# UNITED STATES PATENT AND TRADEMARK OFFICE

10/591,116

<b>Office Action Summary</b>	<b>Application No.</b> 10/591,116	<b>Applicant(s)</b> THOMASSET, JACQUES	
	<b>Examiner</b> ERIK KASHNIKOW	<b>Art Unit</b> 1794

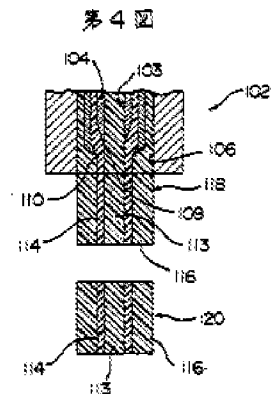
14. In regards to claim 1 and 4 Kawaguchi et al. teach a multilayer structural molded material comprising a synthetic resin material with an inside and outside layer(116), with the outside layer surrounding the inside layer(114)(Abstract). Figure 4 shows an embodiment of this invention wherein there are two inner layers (114 and 104), and the article contains an axis of symmetry (down the middle of the drawing). One can see from the drawing that the layers are partially one on top of each other and perpendicular to the wall on top (the wall parallel to the top of the page).
